Columbia County Building Permit

In compliance with the directive that I received from Mr. Joe Haltiwanger issued with regard to my property at 7018 SW SR 47 on December 13, 2005, I am reporting to you on results of structural evaluations on a residential home at the above listed address. According to the professional engineers that examined this structure, your inspectors were indeed correct with regard to structural deficiencies in this project. Additionally, during an inspection yesterday, a structural engineer pointed out that completed work seriously deviated from permitted plans. To him, this constitutes a serious violation of the permit obtained for this project.

M_gold design and consulting has been engaged to evaluate the architectural design drawings of the *Remodeling and Addition to Existing Residence for Mr. Ed and Diane Bishop White* dated 9 May, 2005 with revisions on 21, July 2005; 23 July, 2005; 13 September, 2005; and 13 November 2005 as provided by Associated Florida Architects, Inc. The drawing set was signed and sealed by Mr. Robert S. Taylor, Sr., Architect, AR-0007526. We inspected the remaining existing structure and unfinished construction of the proposed

Existing Residence

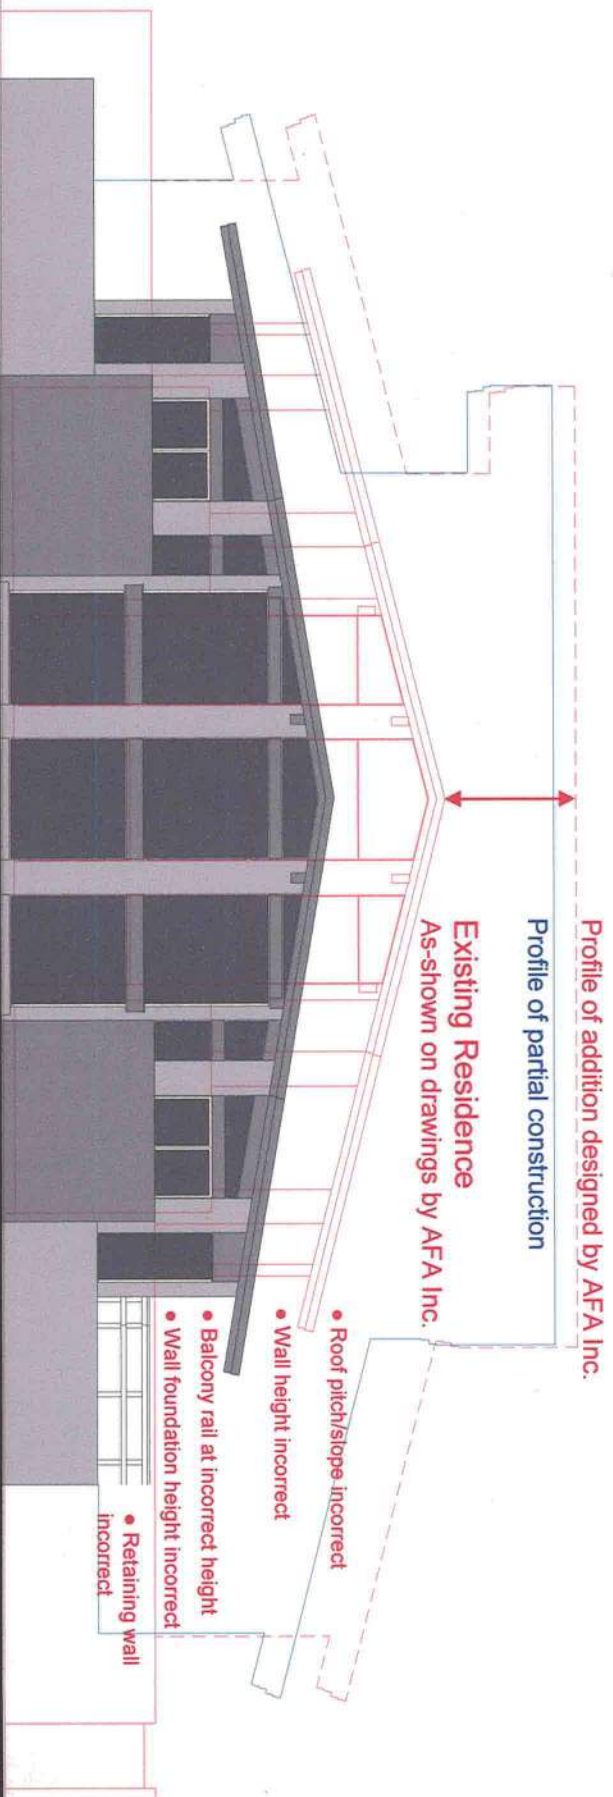
Field measurements were conducted to verify that the existing roof pitch has a slope of 2 feet of rise in 12 feet of run (2 in 12). The drawings prepared by Associated Florida Architects, Inc. represents the existing roof as having a 3 in 12 roof pitch. Field measurements were also used to verify the height of bearing at the lower eave walls to establish a reference for projecting the roof slope. We found the height of the existing wall at the lowest roof bearing to be approximately eight feet (8' - ½" actual) from the top of slab to the roof bearing point. The architectural drawings provided by Associated Florida Architects, Inc. , incorrectly, show this existing height of bearing to be nine feet (9') — an error of 1'-0".

- *The elevation drawings show the existing walls at the lowest roof bearing to be approximately 9' tall. Field measurements revealed this dimension to be 8' - 1/2". This error can cause substantial problems in construction especially with a two-story, low roof slope design.*

AFA, Inc. is Associated Florida Architects, Inc., the incorrect elevation drawing shown in red above is taken from Sheet A-4.01 updated 13 Sept. 2005 and signed and sealed by Robert S. Taylor Sr., AR 0007526.

We recommend a complete redesign of the addition to be architecturally compatible with the existing home. In order to use conventional structural systems and that would meet or exceed the standard of the Florida Building Code, the existing addition should be demolished. The incorrect 3 in 12 roof pitch and excessive building height results in massing and structural incongruities in the present construction that poses such a complex puzzle of questions regarding the usability of the slab as a 'correct footprint'; a suitable foundation for structural bearing; and the probable relocation of in-slab elements such as plumbing and electrical systems renders the slab likely unusable. Detailed structural analysis would be required to verify the integrity of the slab which would add expense and may prove it to be useless. Therefore, we suggest a complete demolition of the current phase of construction as the most efficacious solution to achieve an architecturally compatible and complete residential addition.
